T53 Engineering Product Support Notice – PT Bearing Heat Shield Repair

CAGE CODE: 08HK5		Page 1 of 5
OVERHAUL/REPAIR INSTRUCTIONS		
ATE-2090 REV. ORG. DATE: 2-15-23		
PART NUMBER: 1-140-182-01		
APPLICATION <input checked="" type="checkbox"/> COMMERICAL <input checked="" type="checkbox"/> MILITARY REPAIR <input checked="" type="checkbox"/> MINOR <input type="checkbox"/> MAJOR	DISTRIBUTION & RESTRICTIONS <input checked="" type="checkbox"/> ATE PROPRIETARY INFORMATION <input checked="" type="checkbox"/> ACCOMPLISHMENT OF THE REPAIR/REWORK.	DOCUMENTATION <input checked="" type="checkbox"/> MANUAL AFFECTED/MAINTENANCE MANUAL SECTION 72-40-00
REASON FOR INSTRUCTIONS/DESCRIPTION This repair is introduced to correct the loose assembly fit for the 1-140-182-01 Heat Shield that is allowing the cover to vibration during engine operation. See sheet page 2 for detailed repair instructions.		
Engine Model: T5313B Part Number 1-000-060-13 and T5317 Series Part Numbers 1-000-060-21,29,30,32 and T53L series.

Air Technology Engines (ATE) Repair Instruction

PT Cover, Exhaust Diffuser, 1-140-182-01

PT Cover (Heat Shield)
1-140-182-01

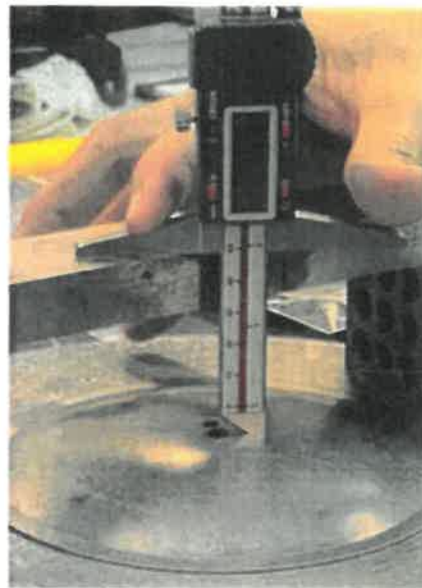
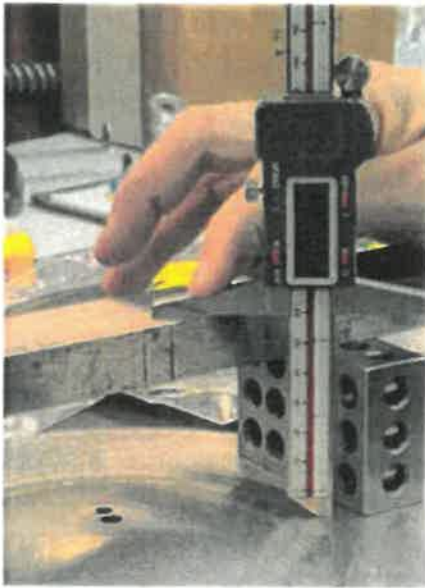
The current Maintenance Manual Instruction 72-40-00 introduced a loose (no cover plate rim contact) assembly fit for the 1-140-182-01 Heat Shield. This loose fit may allow the cover to vibrate during engine operation, leading to vibratory failure and ejection from the engine. In addition, the heat shielding intent to the PT Bearing Package may be reduced, causing higher Bearing and Seal operating temperatures. This ATE Repair Instruction restores the interference/pinch fit required (.010-.020 inch), and complies with the original Lycoming Engine Design Intent.

1. Remove 1-140-182-01 PT Cover. Removal of 1-140-640-03 Rear Bearing Cover is Optional.
2. Inspect PT Cover 1-140-182-01 for dimensional and physical inspection. If physical surface damage is evident (bolt hole edge wear, outer circumference contact surfaces fretted and worn, bolt hole edge cracks i.e.) replace part. (No cracks acceptable)
3. PT Cover 1-140-182-01 Height -Dimension A, (See Illustration) Measure height from outer flange to raised center surface of PT Cover, record results as Dimension A in table provided.

(A) .392
.408

Recommended Method of Inspection - Dimension B

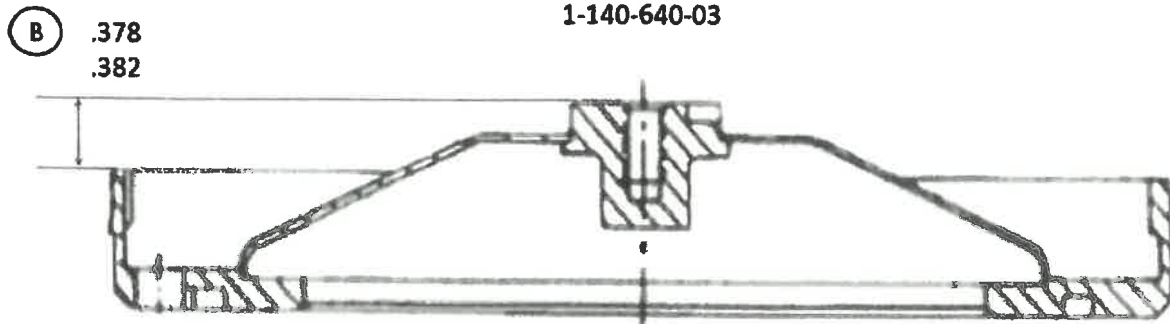
4. Rear Bearing Cover 1-140-640-03 Dimension B, (See Illustration) Measure height from outer rim to center of bearing cover and record as dimension B. NOTE: This can be accomplished with the rear bearing cover installed or removed from the engine (Shown as removed).

5. Subtract the recorded dimension on the 1-140-640-03 (Dimension B) from the recorded dimension on the 1-140-182-01 (Dimension A).

Example: (Dim A) 0 .400 – (Dim B) 0 .380 = .020 inch (an interference/ pinch fit of .020 exists). AN INTERFERENCE FIT OF .010 to .020 inch is required.
